Attachment 1 – Modified Text

Note for Commenters: Modifications to this document as proposed and released December 7, 2007 are shown in underline to indicate additions and ~~strikeout~~ to indicate deletions compared to the original text as presented in the ARB Staff Report: Initial Statement of Reasons released May 4, 2007. Additional modifications to this document are shown in double underline to indicate additions and ~~double strikeout~~ to indicate deletions compared to the last public release of this document on December 7, 2007. Only those modifications shown in double underline and ~~double strikeout~~ are open for comment during this comment period.

State of California AIR RESOURCES BOARD

CALIFORNIA ENVIRONMENTAL PERFORMANCE LABEL SPECIFICATIONS FOR 2009 AND SUBSEQUENT MODEL YEAR PASSENGER CARS, LIGHT-DUTY TRUCKS, AND MEDIUM-DUTY PASSENGER VEHICLES

ENVIRONMENTAL PERFORMANCE LABEL STYLE REQUIREMENTS

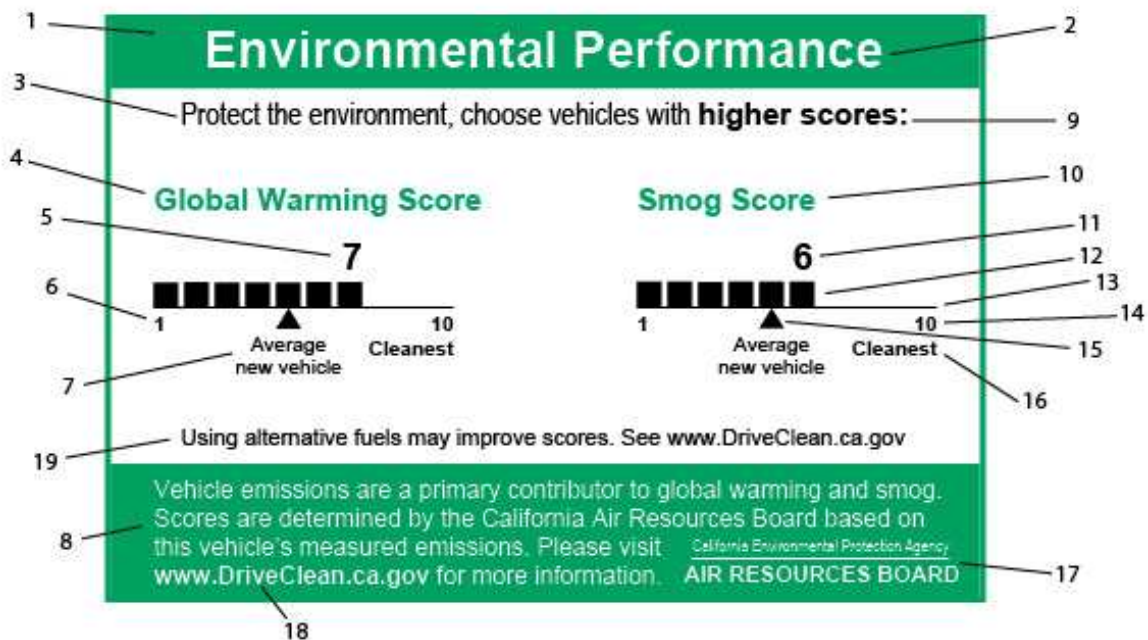
1	Label Background 6 x 4 inches whole; top green: 6 x 0.5 inches; Bottom green: 6 x 1 inches; green stroke: 4 <u>3</u> points; Color: PMS 347 (C or U)
2	font: Myriad Pro <u>Arial Bold</u> ; size: 25 points; color: knocked out of green (appears white)
3	font: Myriad Pro Light <u>Arial Narrow</u> ; size: 15 points; color: Black
4, 10	font: Myriad Pro Semi-bold <u>Arial Bold</u> ; size: 14.4 <u>15</u> points; color: PMS 347 (C or U)
5, 11	font: Myriad Pro Semi-bold <u>Arial Bold</u> ; size: 19.2 <u>18</u> points; color: Black
6, 14	font: Myriad Pro Light <u>Arial Bold</u> ; size: 9.6 <u>10</u> points; color: Black
7	font: Myriad Pro Light <u>Arial Regular</u> ; size/leading: 9/10.8 <u>10/12</u> points; color: Black
8	font: Myriad Pro <u>Arial Regular</u> ; size/leading: 11.3/13.5 <u>12/14</u> points; color: knocked out of green (appears white)
9	font: Myriad Pro <u>Semi-bold Arial Bold</u> ; size: 15 points; color: Black

12	size: 0.167 x 0.167 inches <u>12 x 12 points</u> ; color: Black; distance: 0.042 inches <u>3 points</u> apart
13	Scale Line: length: 2.05 inches <u>147 points</u> ; stroke: 1 point; color: Black
15	size: 0.167 x 1.11 inches <u>12 points each side</u> ; color: Black
16	font: Myriad Pro Semi-bold <u>Arial Bold</u> ; size: 10.5 <u>10</u> points; color: Black
17	California Environmental Protection Agency / Air Resources Board logotype: Top Row: font: Myriad Pro Regular <u>Arial Narrow</u> ; size: 7 <u>8</u> points (Title Case) Bottom Row: font: Myriad Pro Regular <u>Arial Bold</u> ; size: 12 <u>11</u> points (All Caps) Line weight: 1 point; <u>length: 126 points</u> Color for all: knocked out of green (appears white)
18	www.DriveClean.ca.gov: Font: Myriad Pro Semi-bold <u>Arial Bold</u> Size: 12 points Color: knocked out of green (appears white)
19	<u>Flex Alternative</u> fuel phrase (variable element): font: Myriad Pro Light <u>Arial Regular</u> ; size: 9/10 <u>11</u> points; color: Black

Note for Commenters: For simplicity in viewing the proposed modifications, the entire label is reproduced here without underline or ~~strikeout~~ or double underline or ~~double strikeout~~ to provide a sample label reflecting the proposed modifications. However, the only items proposed for modification from the original proposal, as noticed for comment on December 7, 2007, were the movement of the phrase “Average new vehicle” noted in 7, the movement of the triangle noted in 15 from just right of block 5 to the middle of block 5, the substitution of the number 1, noted in 6, in lieu of 0 below each scale line, and the alternative fuel phrase as noted in 19. Additional changes as proposed in this notice and subject to comment during this comment period are to the text font style, size and location. The text font proposed is now Arial (was Myriad Pro) and standard font sizes (was fractional) are specified. All other requirements as originally proposed and as noticed for comment on December 7, 2007 remain unchanged.
